**DOCUMENT 00 90 00  
ADDENDUM**

**ADDENDUM NO. [4]                      Date: November 21, 2018**

**RE:                      GLENWOOD COMMUNITY SCHOOL DISTRICT  
ATHLETIC COMPLEX IMPROVEMENTS BID PACKAGE 2 REBID  
400 SIVERS ROAD  
GLENWOOD, IOWA 51534  
HSR PROJECT NO. 18005**

**FROM:                  HSR Associates, Inc  
100 Milwaukee Street  
La Crosse, WI 54603  
(608) 784-1830**

**M100R**

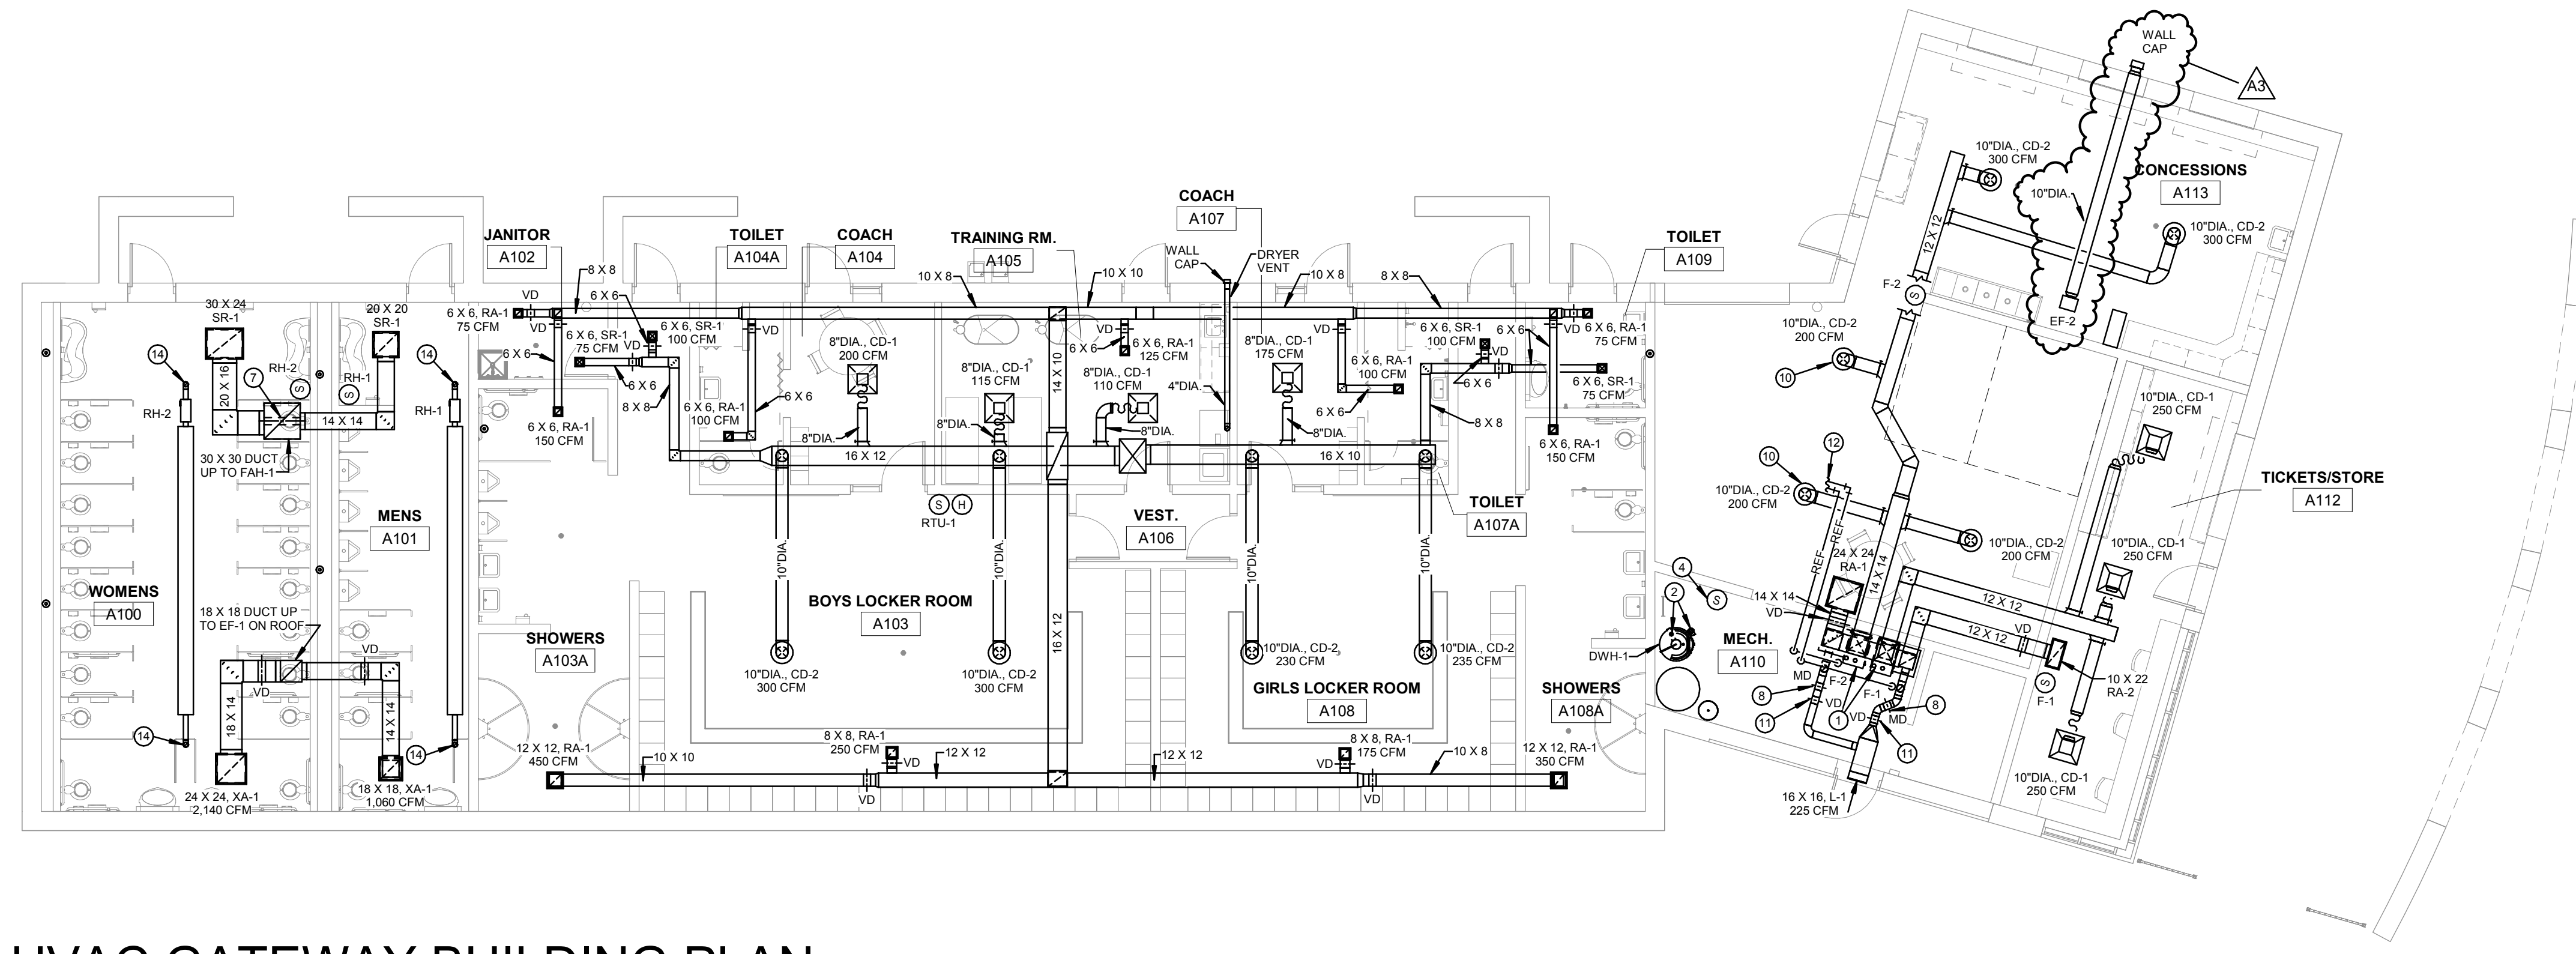
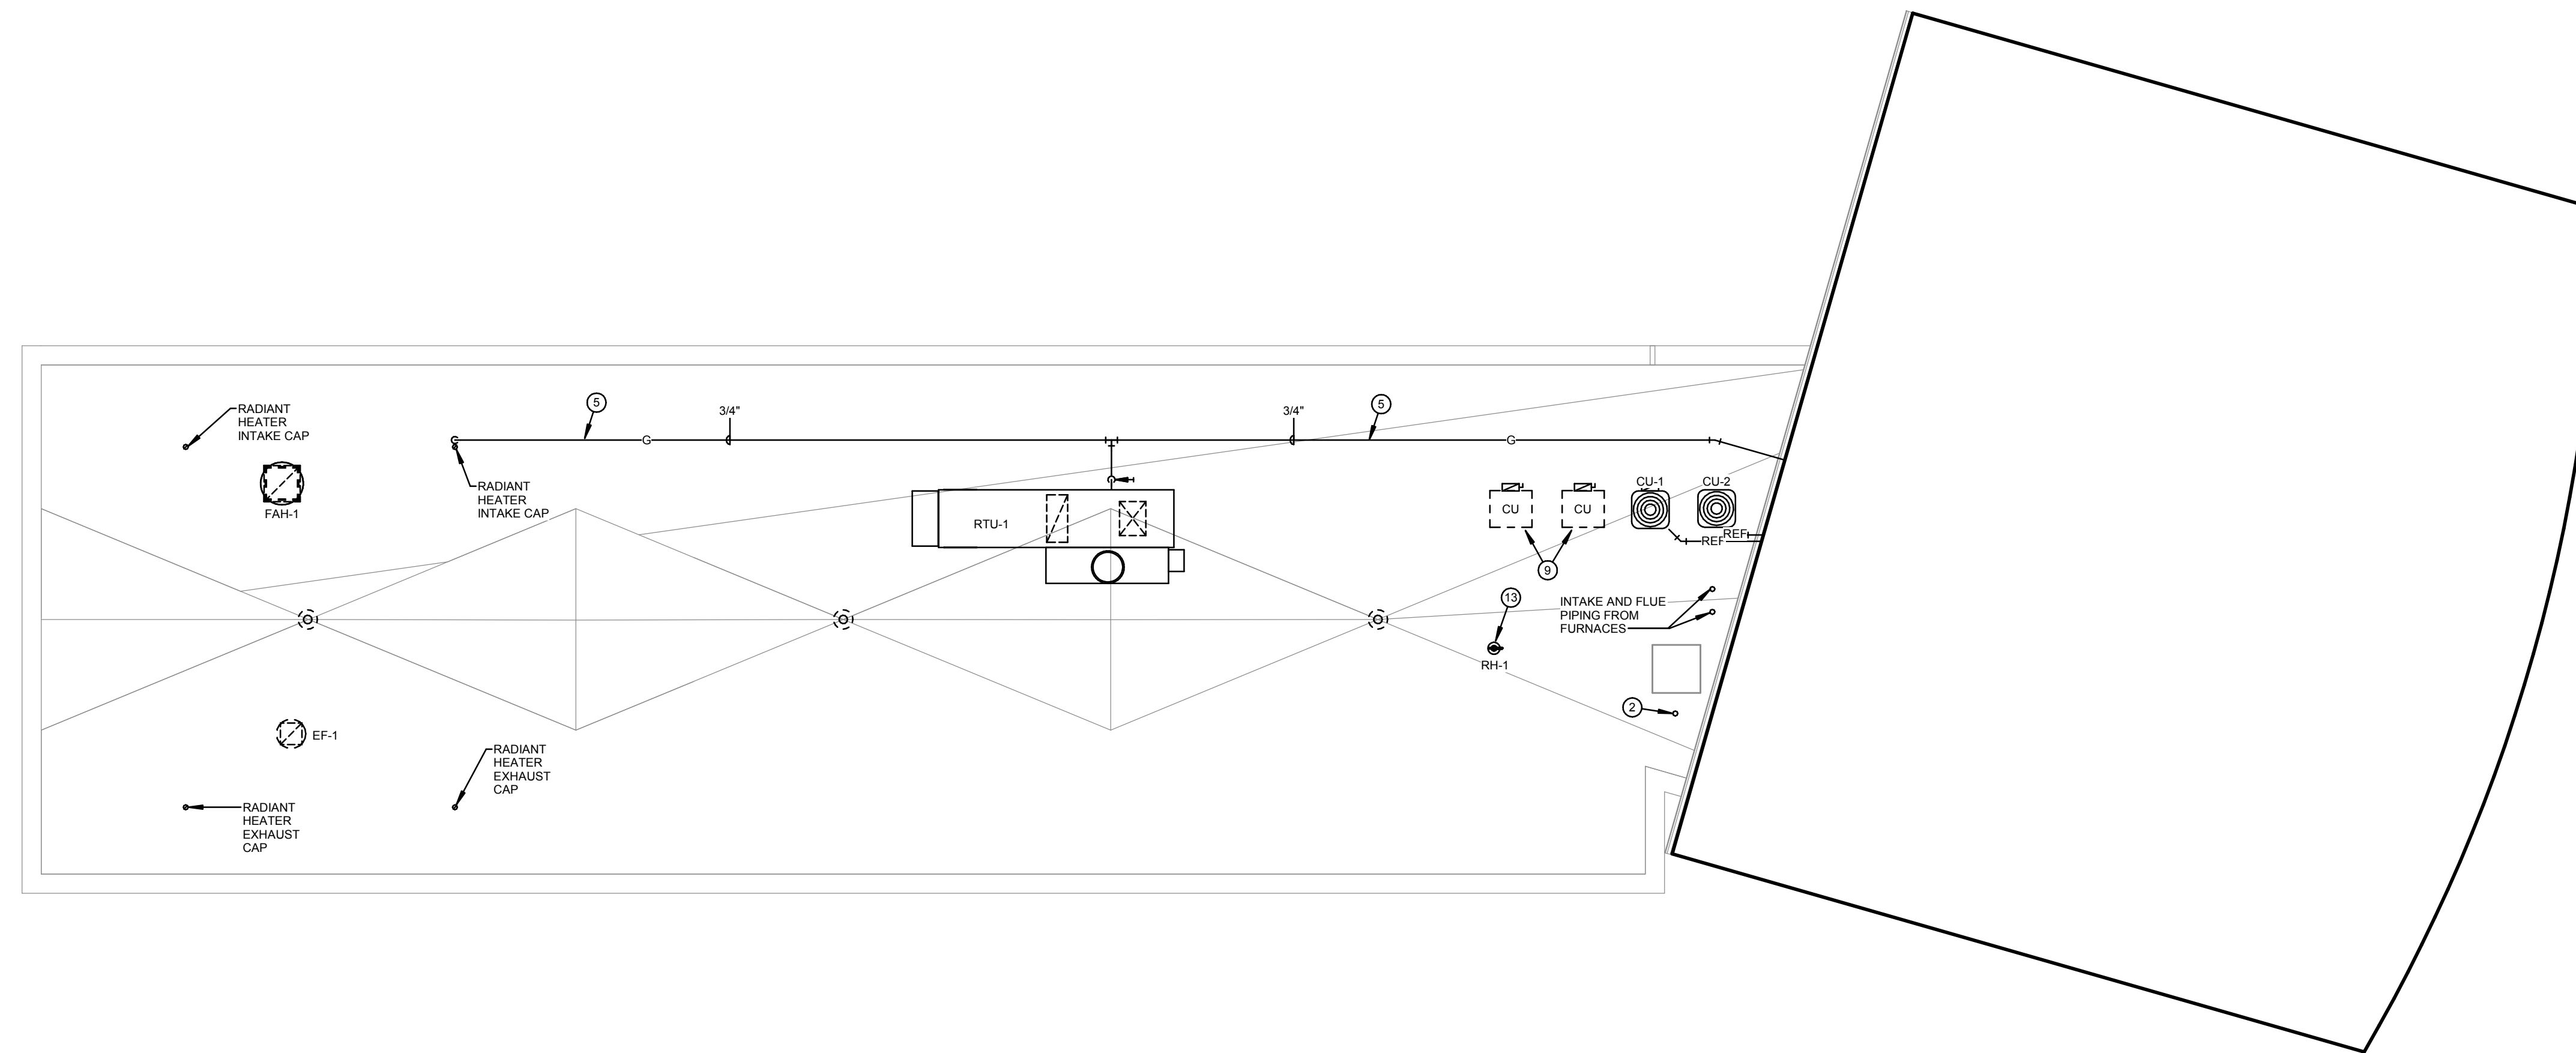
6. Sheet M100R GATEWAY BUILDING HVAC PLAN 30 x 42 attached hereto.
- a. Revisions clouded on Drawing
  - b. Changed location and duct size of exhaust (EF-2).
